## 1. Update power-up sequence: A stable OpenLDI PCLK required before OpenLDI PLL comes out of reset

Status: The updated power-up and initialization sequences will be added in the next revisions of the DS90UB947-Q1 and DS90UH947-Q1 datasheets.

**Figure 1. Power Supply Sequencing Diagram**

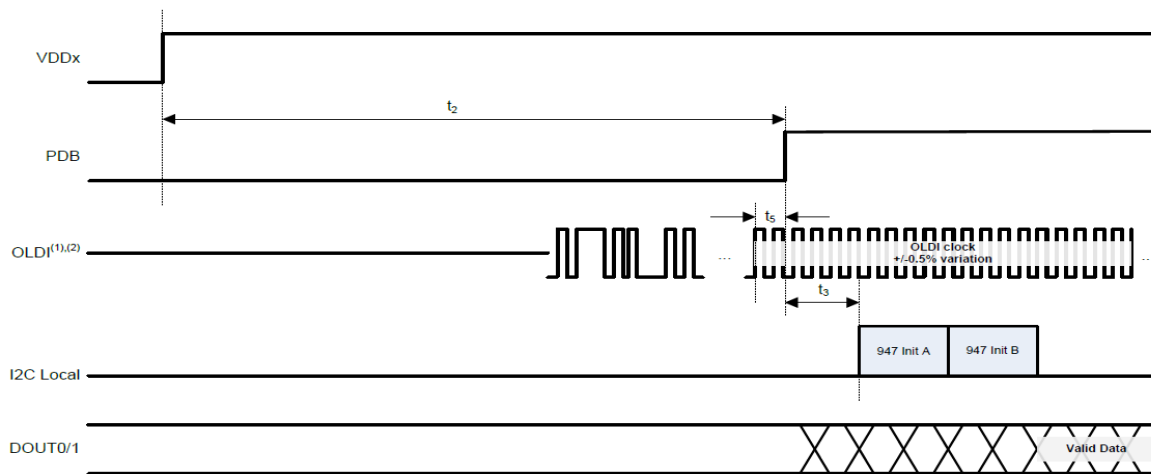
<sup>(1)</sup> It is recommended to assert PDB (active High) with a microcontroller rather than an RC filter network to help ensure proper sequencing of PDB pin after settling of power supplies.

**Figure 2. Initialization Sequencing Diagram**

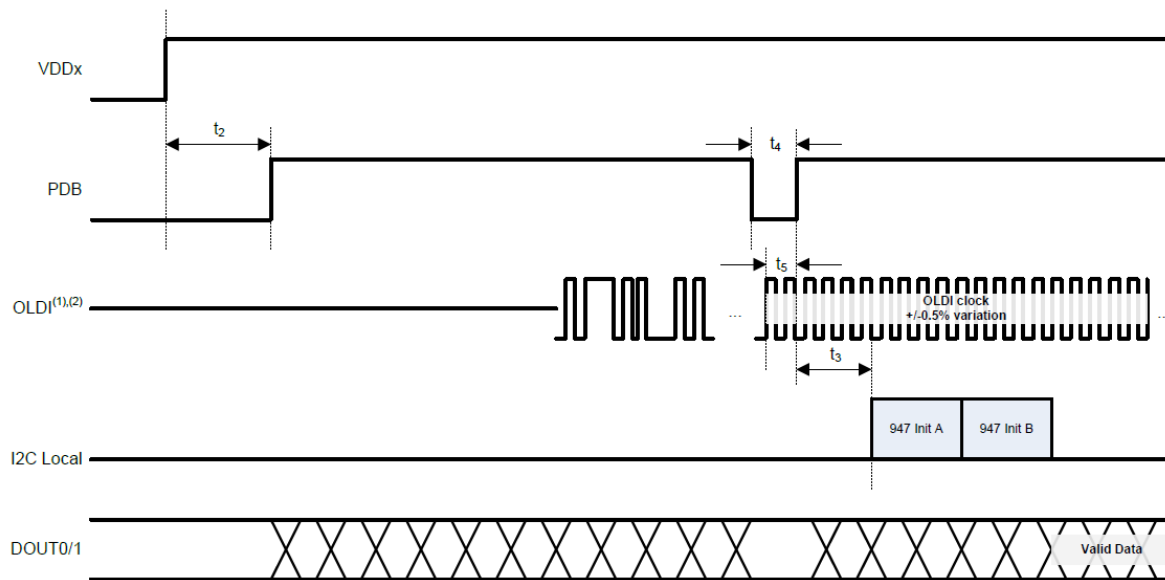
Workaround: Option A: Delay PDB release until after the OpenLDI PCLK has stabilized as shown in Figure 2. Alternatively, the PDB may be toggled again in case it comes up before the PCLK is stable as shown in Figure 3.
